R44 SERVICE BULLETIN SB-110

DATE: 6 January 2022

SUBJECT: C029-3 Tail Rotor Blade Cracks

Crack at leading edge

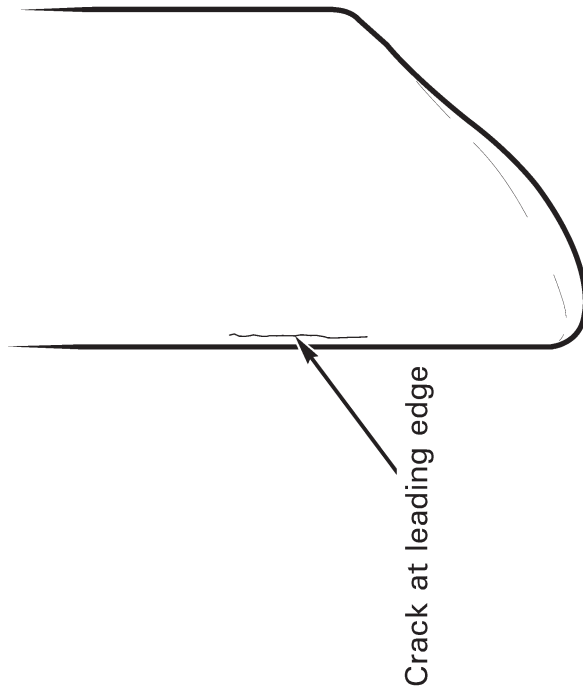
As part of each preflight inspection, perform detailed visual inspection of outboard 12 inches (30 cm) of blade leading edge. If any hairline crack similar to one shown in figure is found, aircraft is unairworthy. Replace blade prior to further flight.
